Planning & Zoning Board

Thursday, June 1, 2023

**MINUTES Regular Meeting
REYNOLDSBURG Planning & Zoning Board
May 18, 2023**

MONUMENT SIGN DETAILS

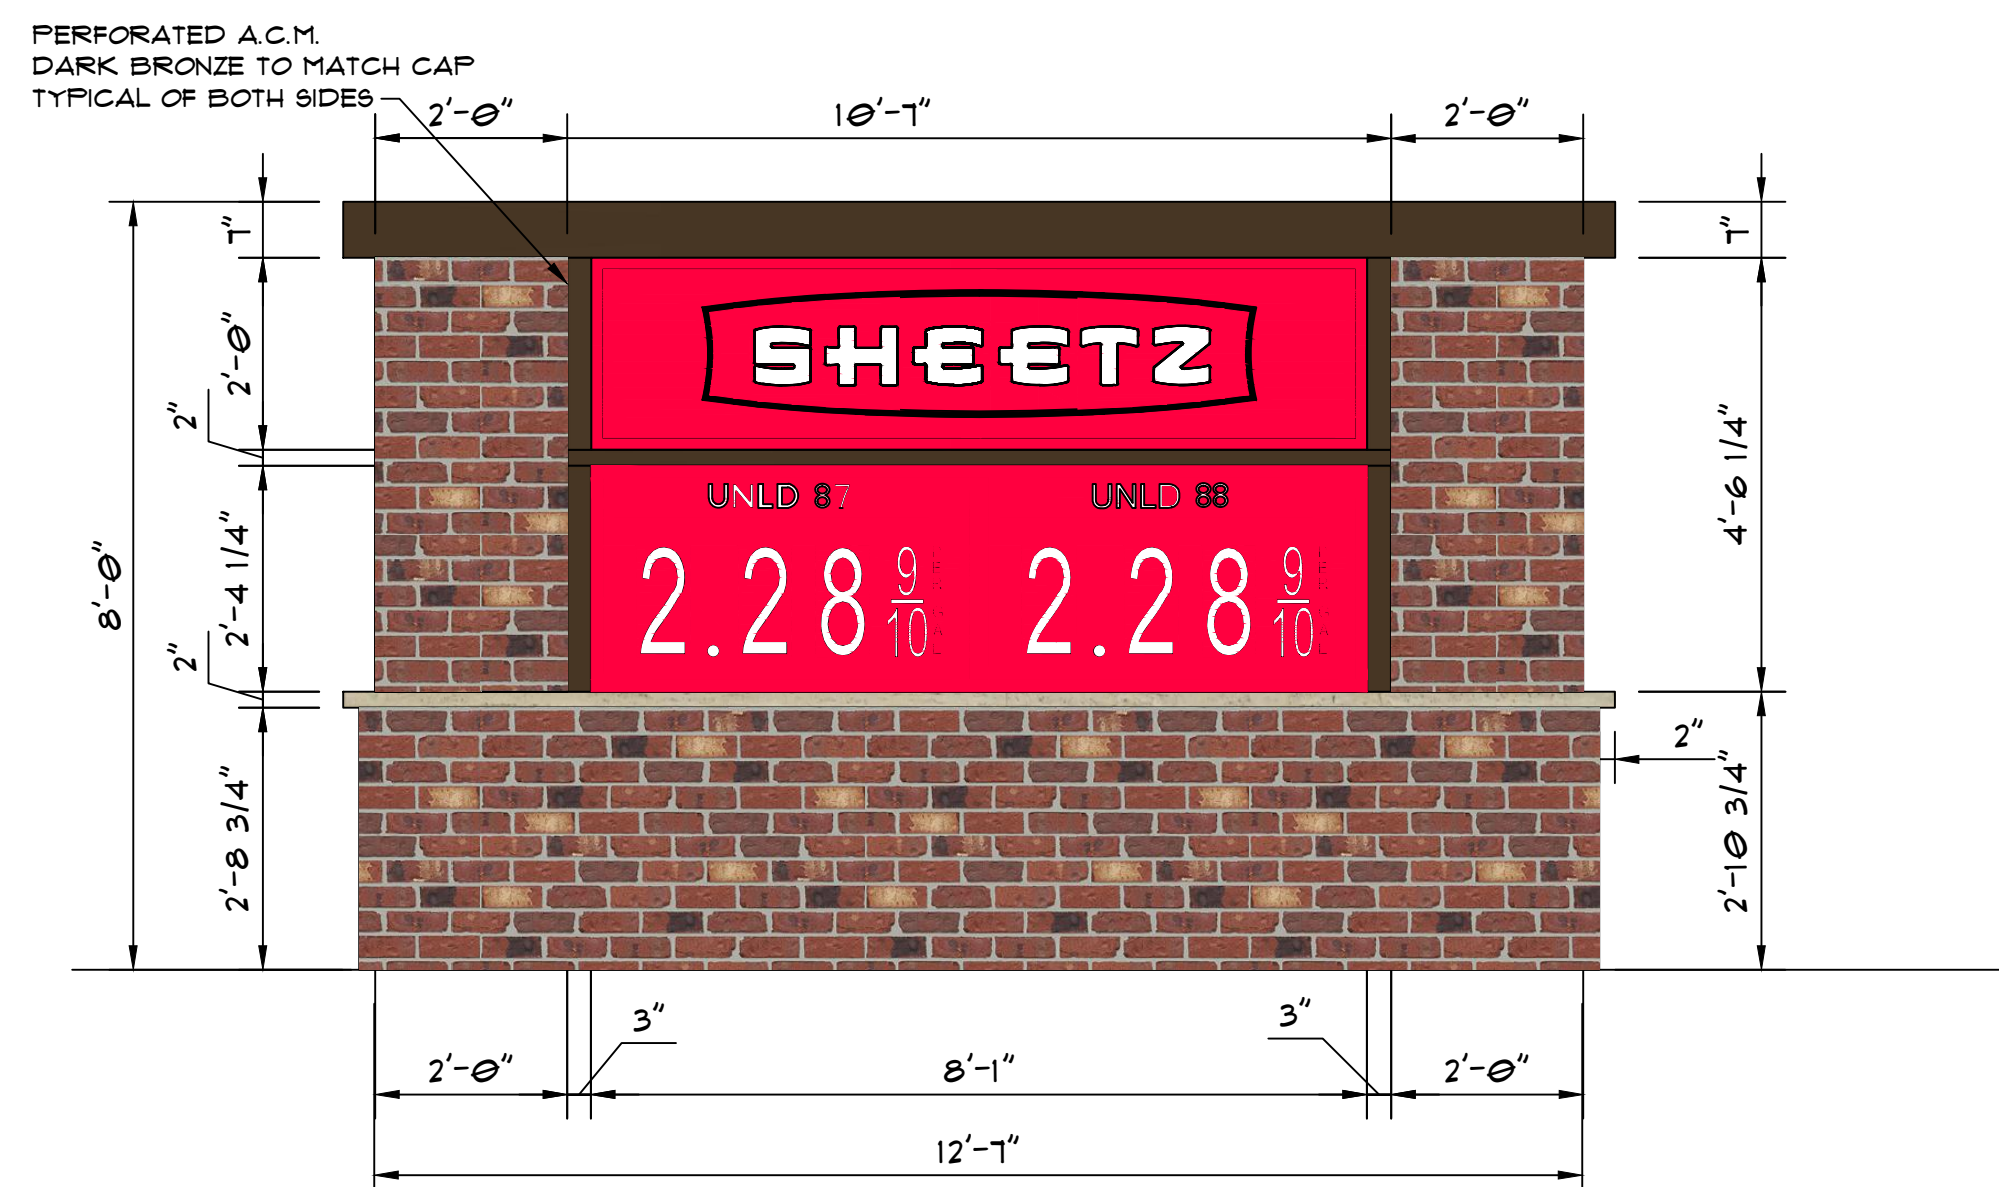
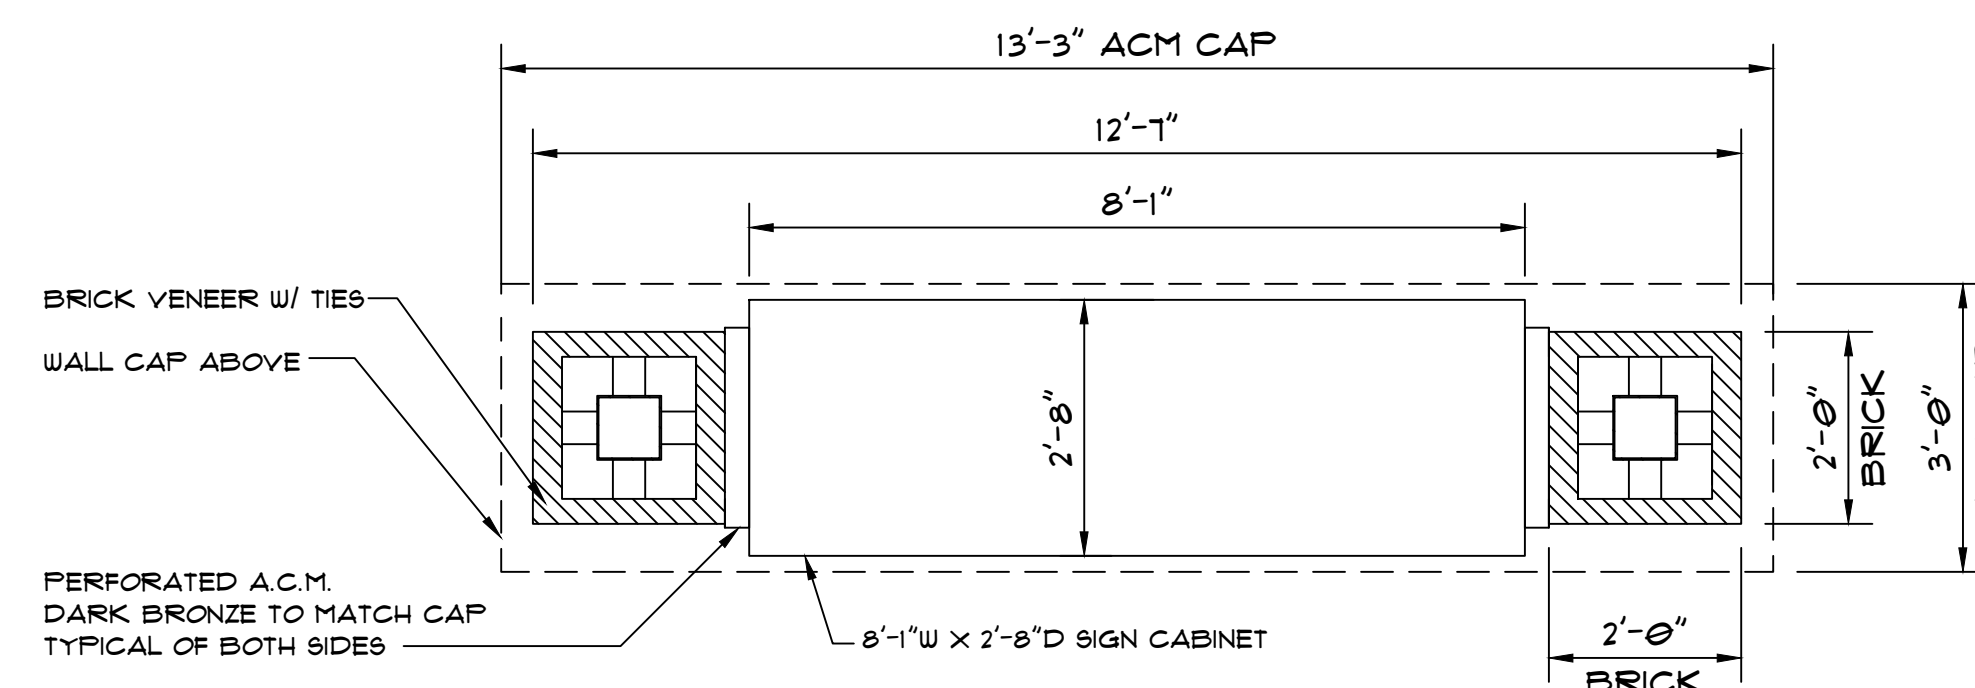
- iii. To allow for a monument sign with 4sf area of changeable copy1105.03 H.i. (Sign C). The electronic sign portion displaying fuel pricing is 19.03 sf and constitutes 52% of the total sign area. The applicant states that the "The price identification cabinet has a static area of 15.02sf and a changeable area of 4sf. The changeable area is 11% of the total sign area." By definition, the Sign Area is "the entire area within a single continuous perimeter enclosing the extreme limits of writing, representation, emblem, or any figure or similar character together with any frame or other material or color forming an integral part of the display or used to differentiate such sign from the background against which it is placed; excluding the necessary supports or uprights on which such

6'-0" TALL MONUMENT SIGN

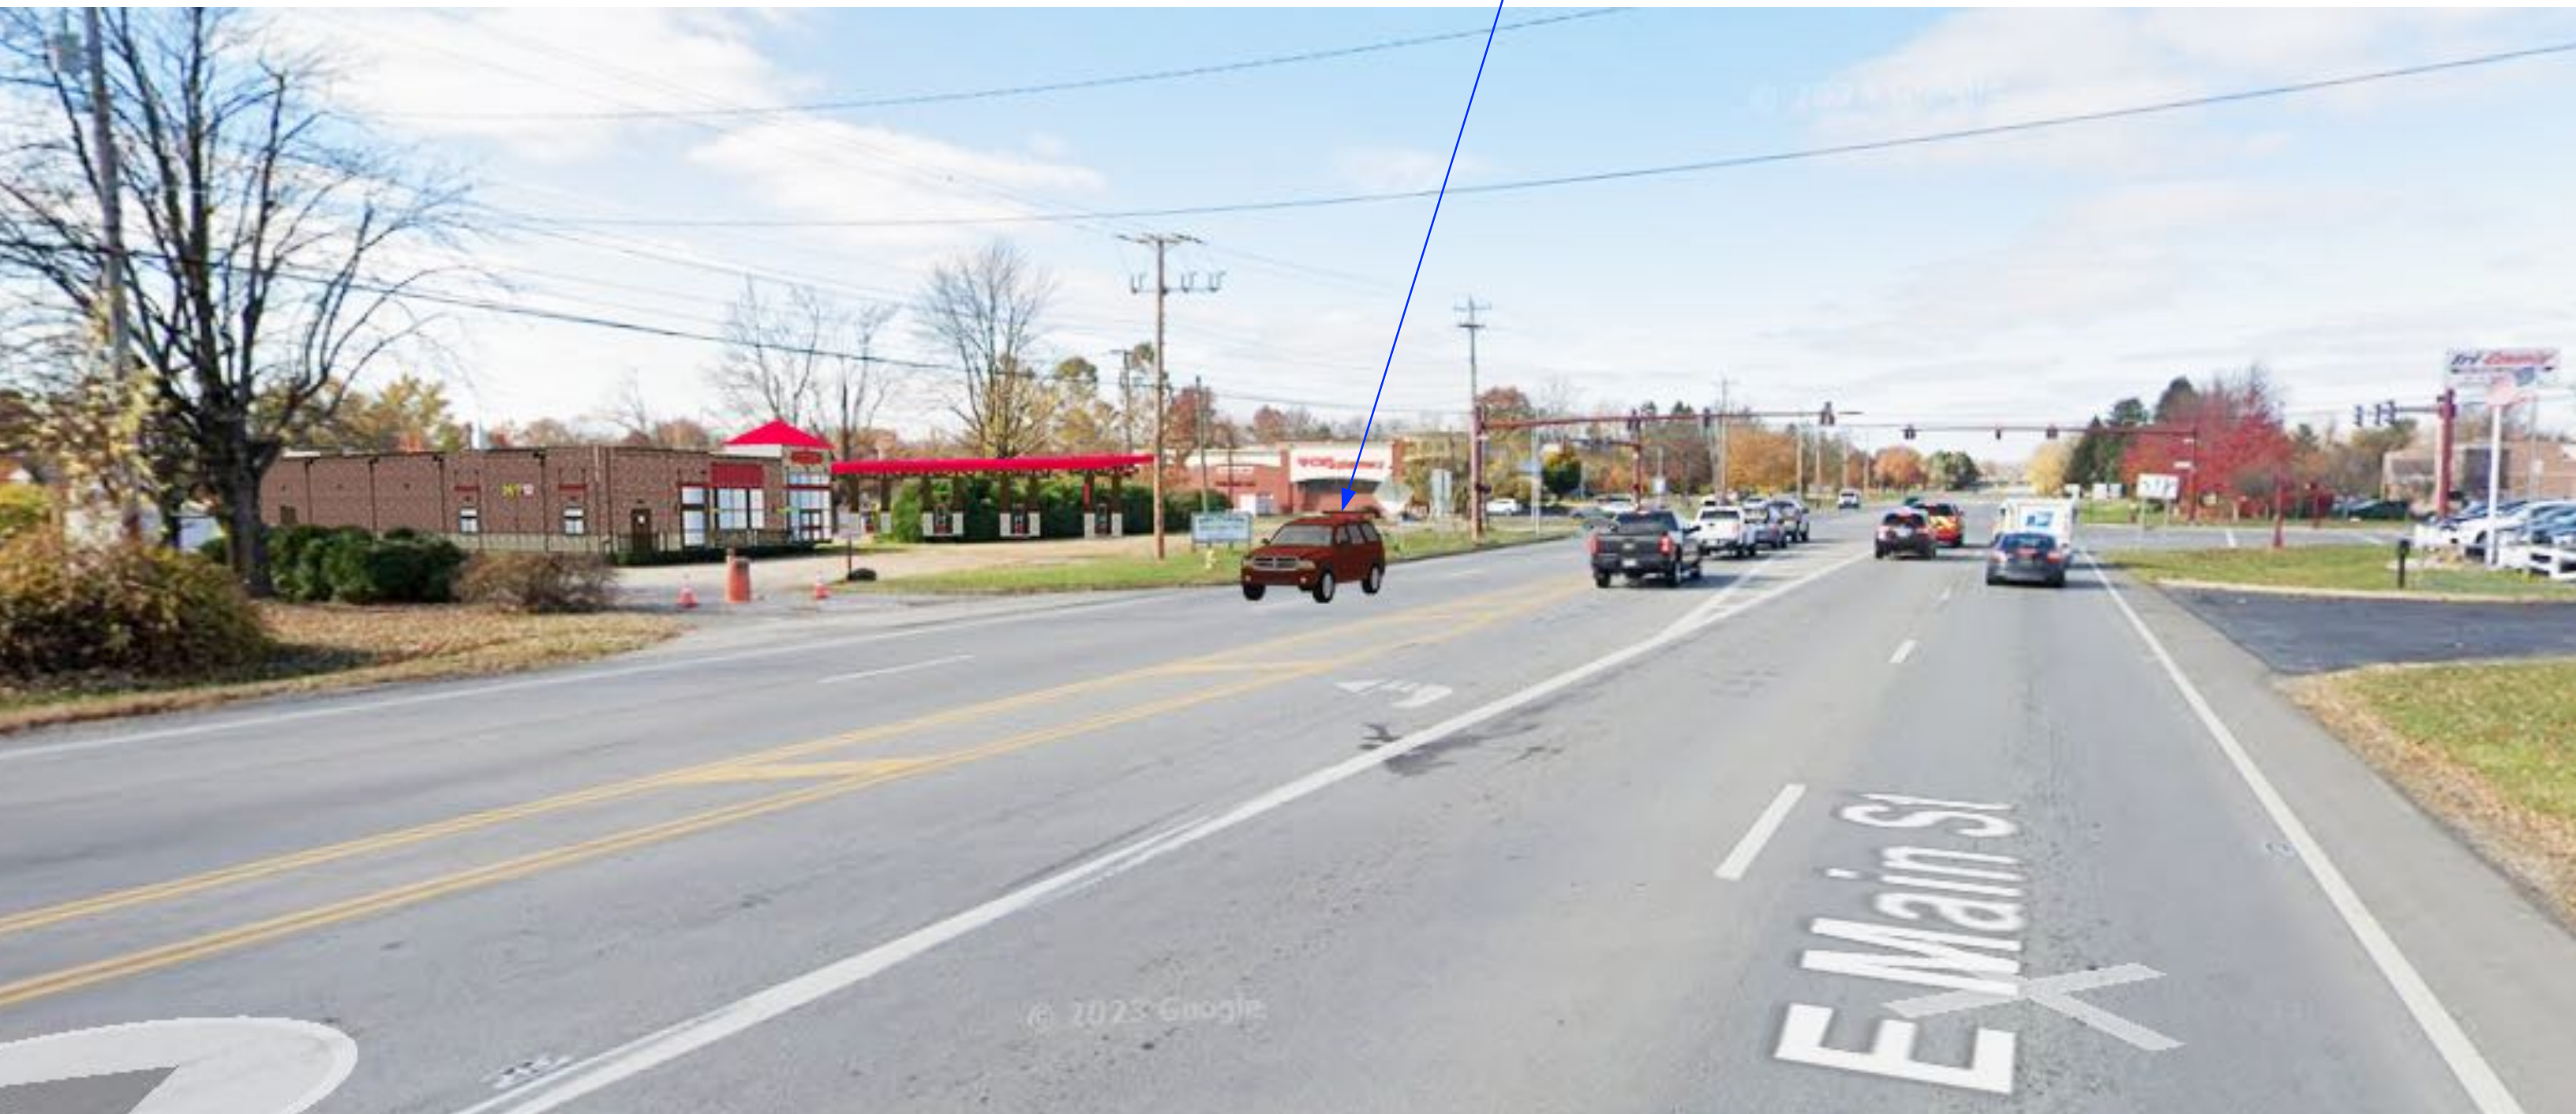
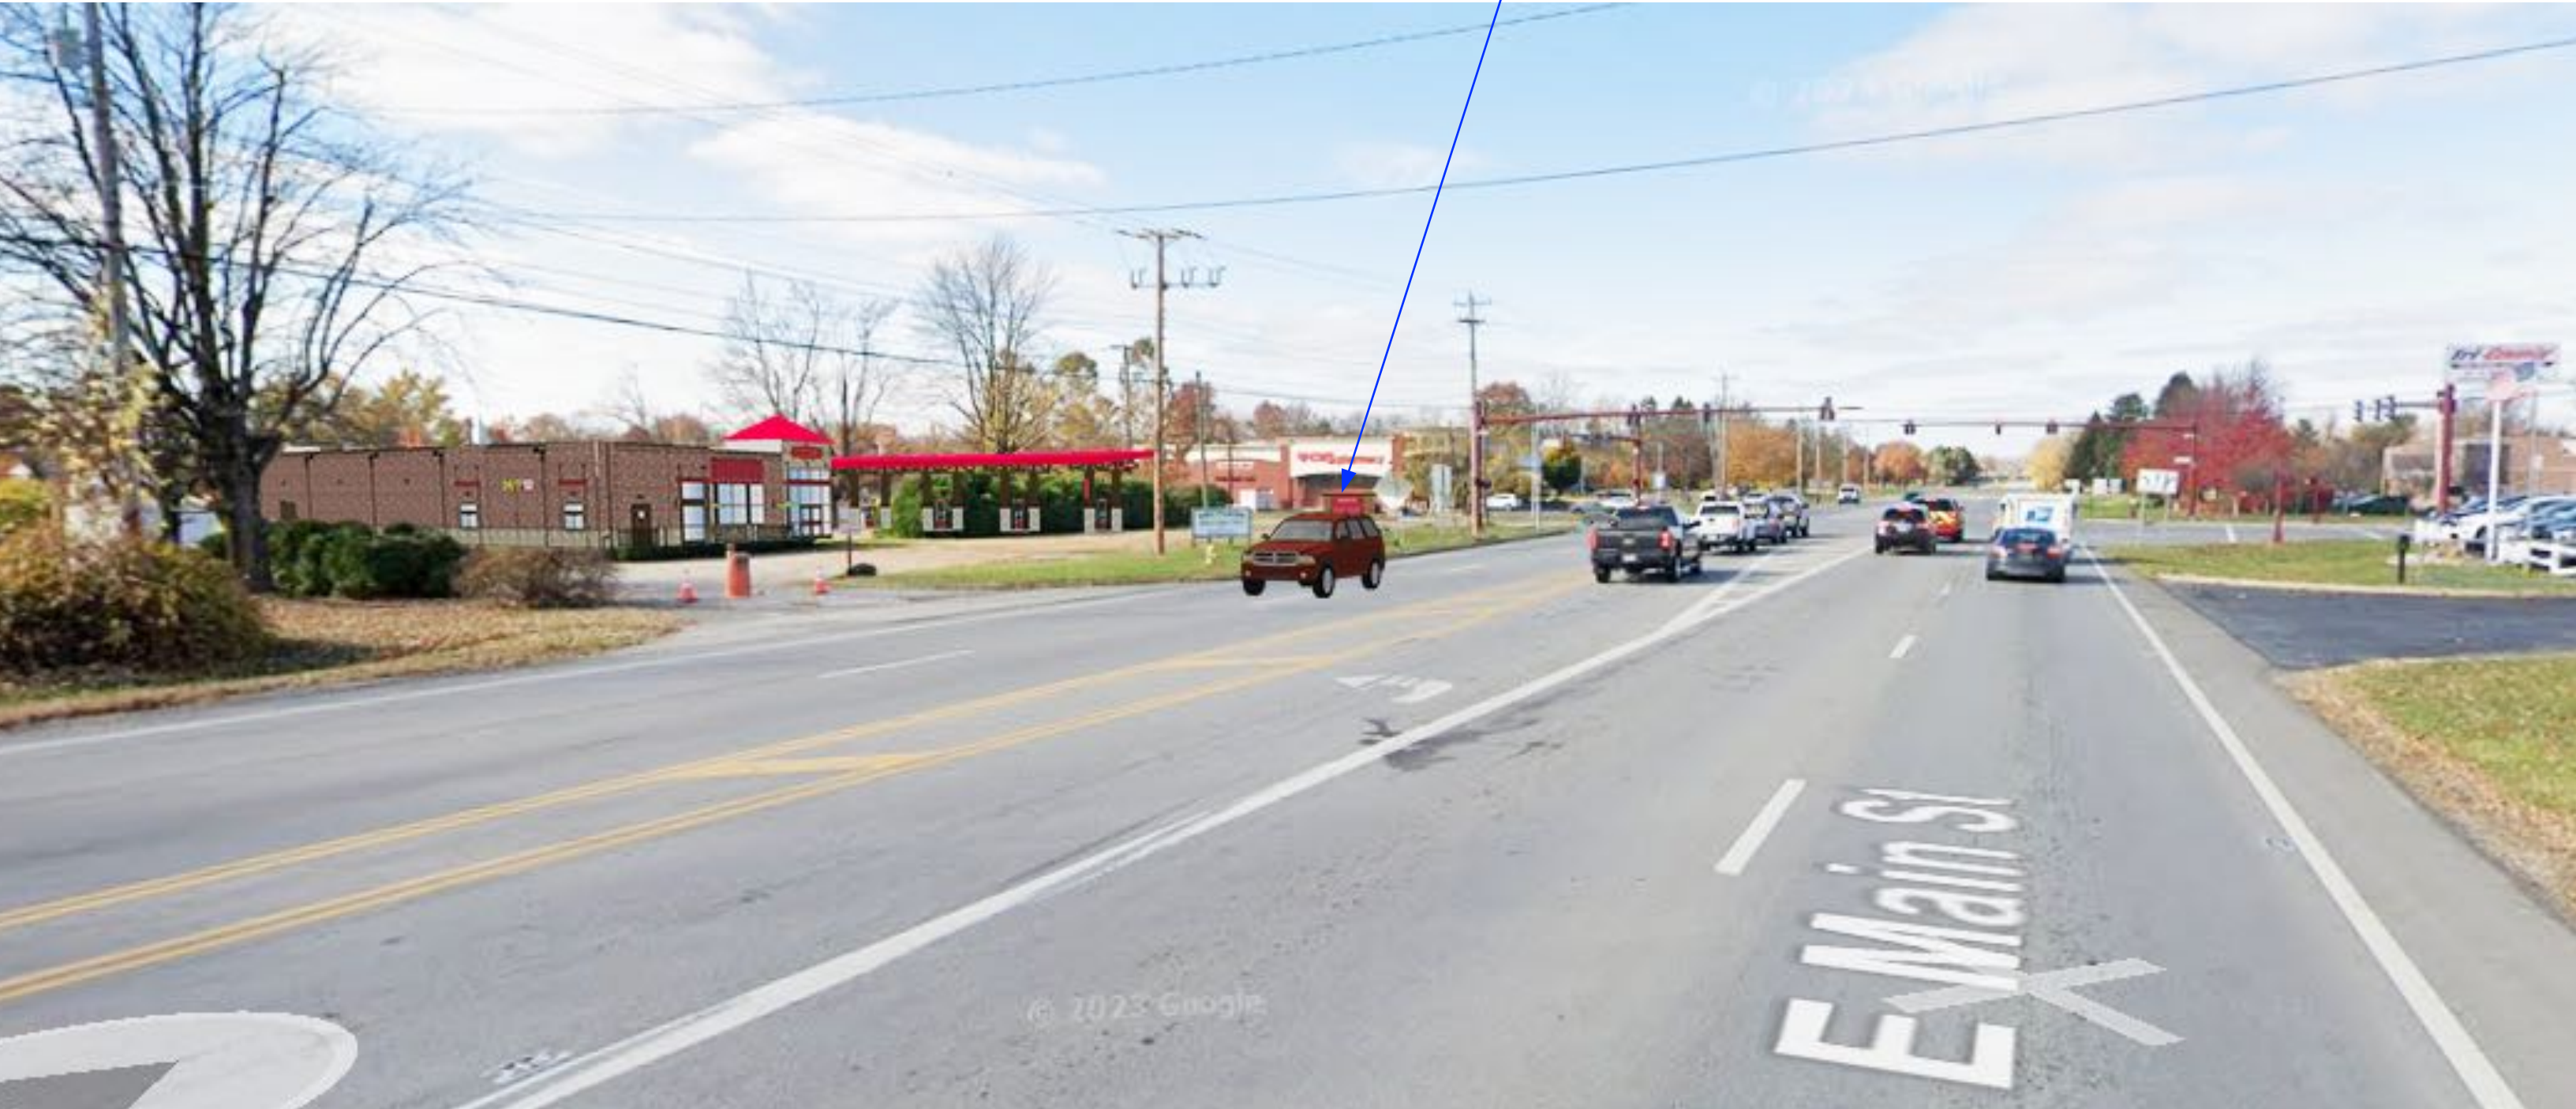
- b. Variances to a monument sign:
 - i. To vary the height the monument sign's height from 6 ft to 8 ft. 1105.03.C.vii.4. (Sign C). The monument sign is required to be set back a minimum of 10 feet from the property line. It appears from the Site Plan to be set back at least 10 feet. Since the sign is located at a similar grade/elevation to the road, there appears to be no reason the sign needs to be higher than the permitted height of 6 feet. Since the previous submission, the applicant has reduced the height of the base to allow for a one-foot decrease in overall sign height.to 8 feet.

At the last hearing, Staff recommended disapproval of the monument sign requested variances for height, sign area, and percentage of electronic sign area. In response, Sheetz modified the proposed monument sign by reducing its height to 8ft. The sign area and the changeable sign area remain the same.

Customers driving west will approach the site at 35mph. The proposed monument sign is 8 ft. It lifts the price signs up to 36.75in. It is reasonable for a gas station to have its gas prices to be visible to passing drivers, and Sheetz has revised its request from 9ft to 8ft. This is the minimal height required. If the sign is limited to 6 ft, the gas prices will only be 10.75in from grade, and 6.75 in from grass height. Requiring drivers to view prices at about 6in from the height of the grass is unreasonable and creates a hardship.

- 1 - Sheetz has removed Sign A.4 MTO according to Staff recommendation per 1105.03.c.8.
- 2 - Sheetz has removed Sign A.5 24/7 according to Staff recommendation per 1105.03.c.8.
- 3 - Sheetz has modified Sign C's height from 9'1"ft to 8ft.
